HUNTSVILLE ACTIVITY CENTER
UPPER LEVEL
DATA AND OTHER FOR MARKUP

1 ARCHITECTURAL FLOOR PLAN - SECOND LEVEL
SCALE: 1/8" = 1'-0"

NEW ACTIVITY CENTER
HUNTSVILLE SCHOOL DISTRICT
HUNTSVILLE, ARKANSAS

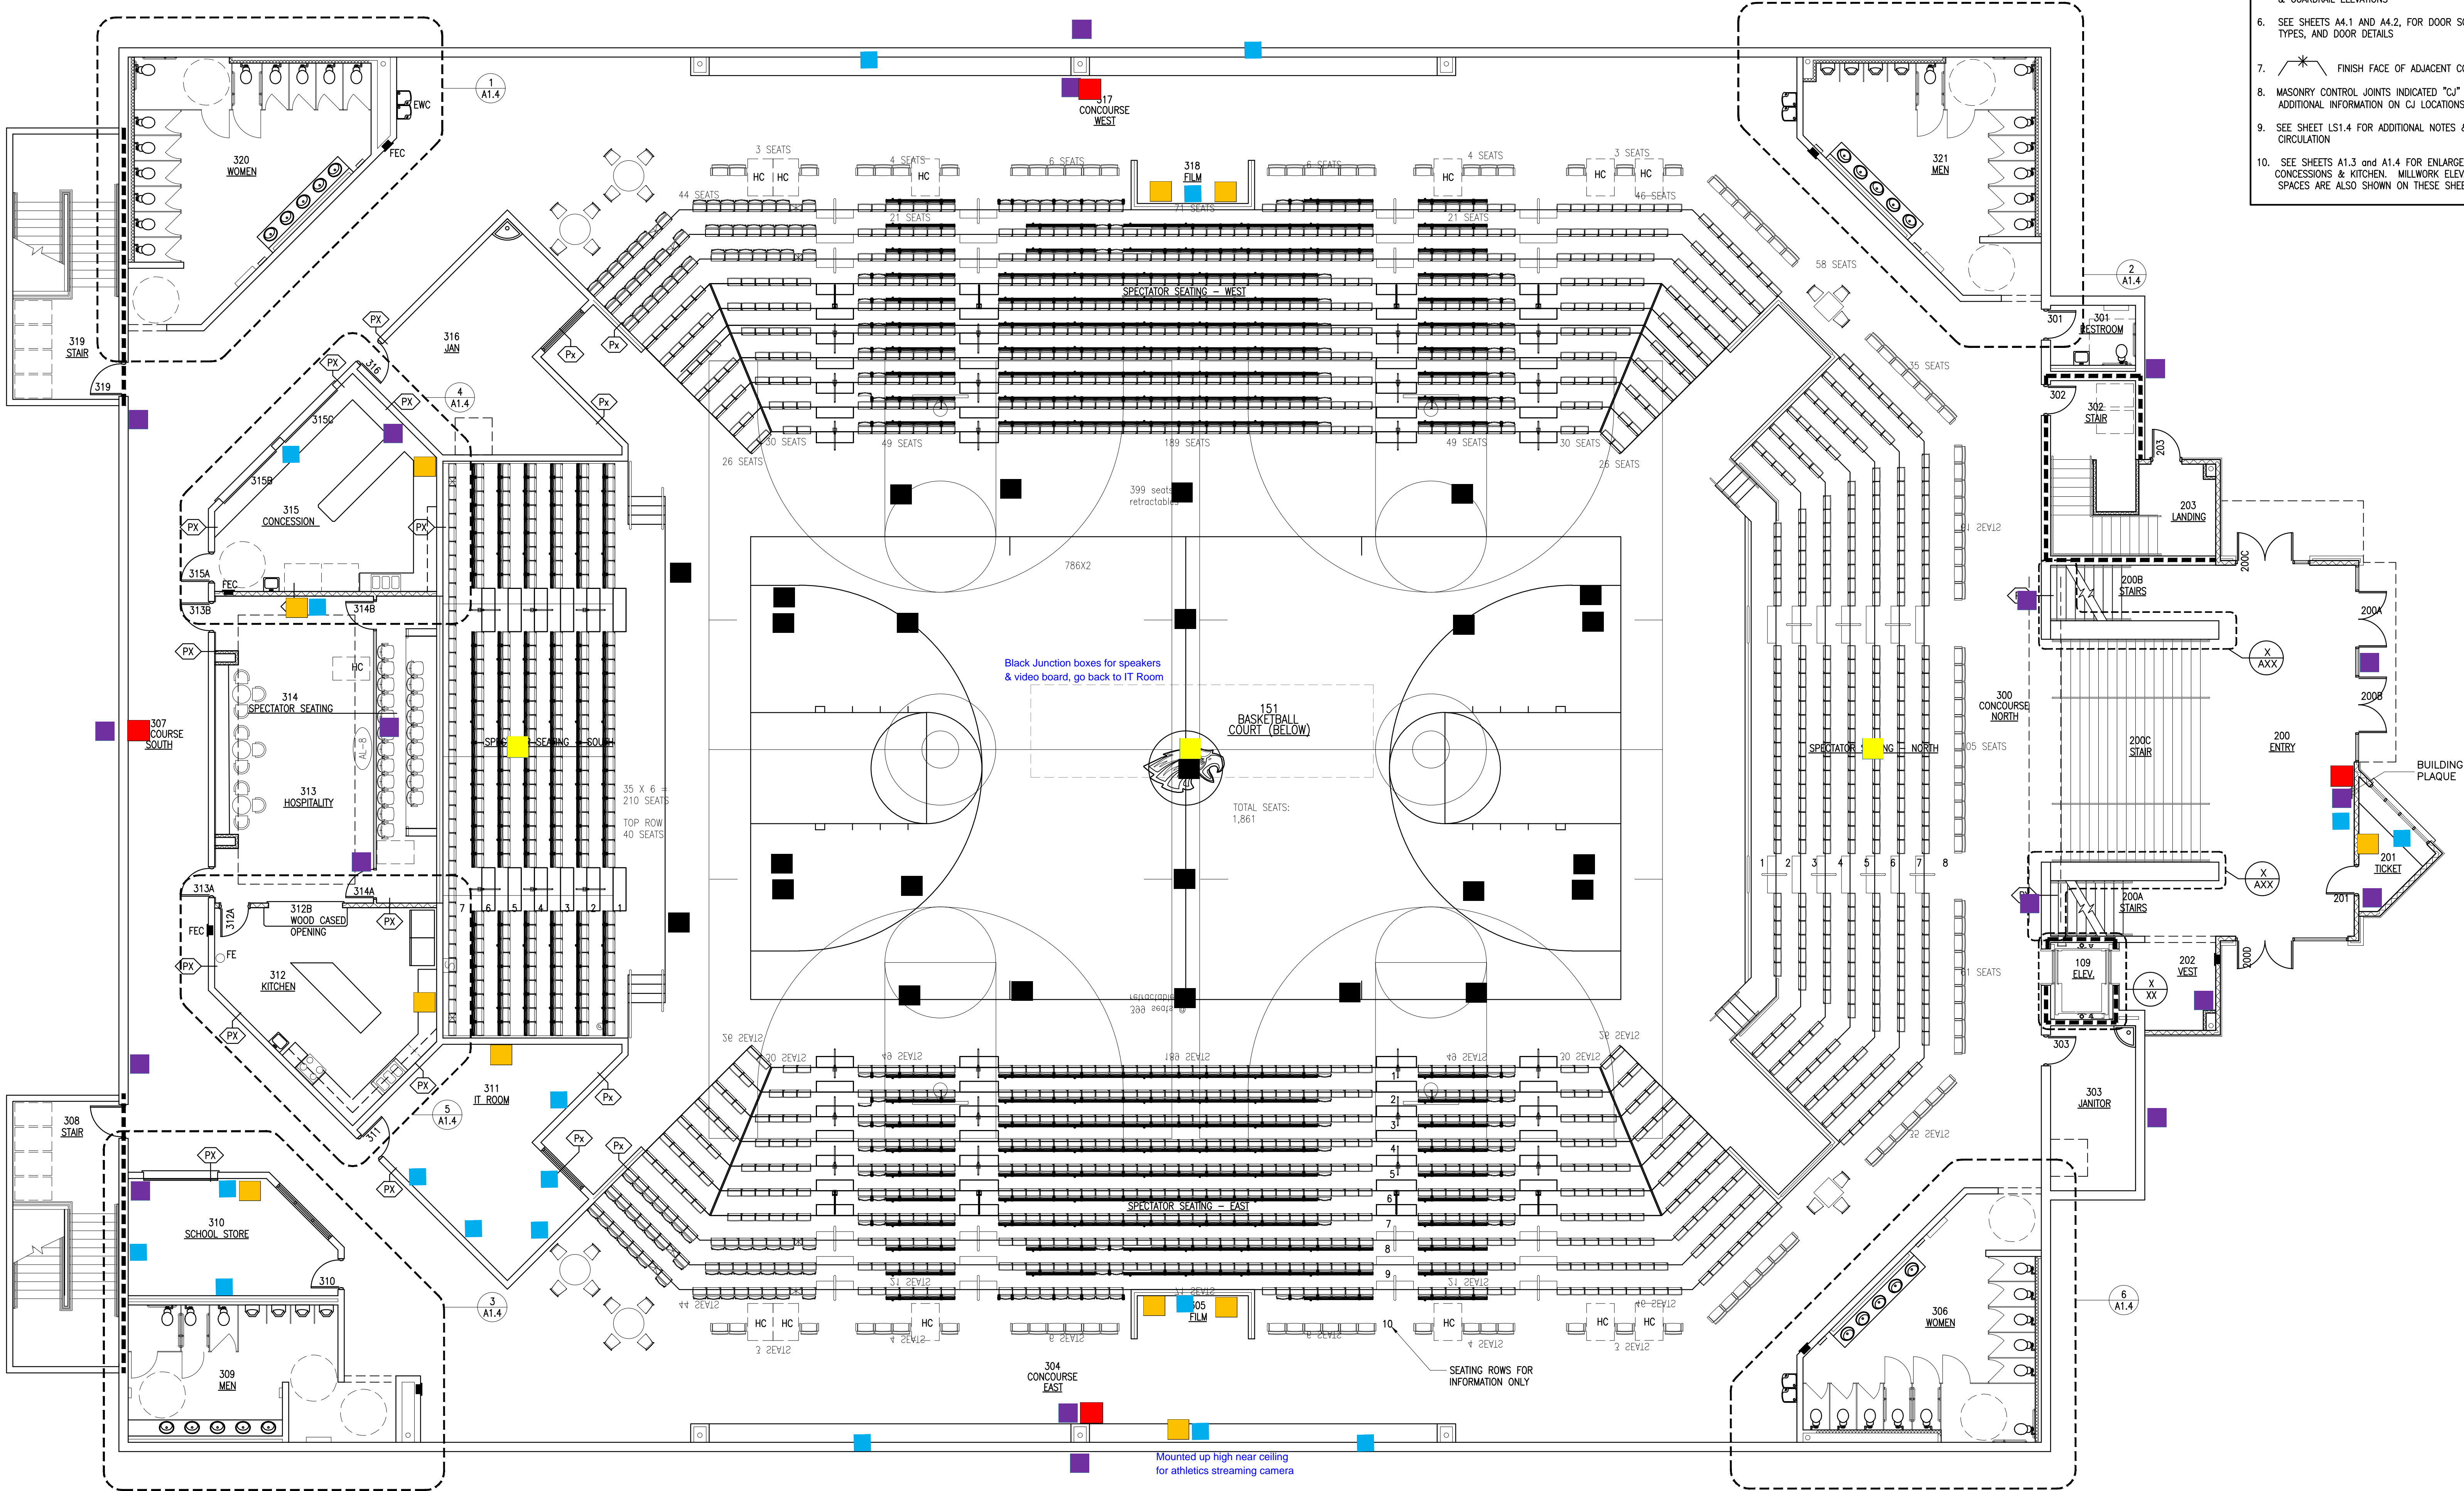
Red = Alert Beacon
Yellow = Access Point
Blue = Data Cat 6 to network room
Orange = Power & Junction Box to IT Rm for TV
Purple = Camera
Black = Junction Box
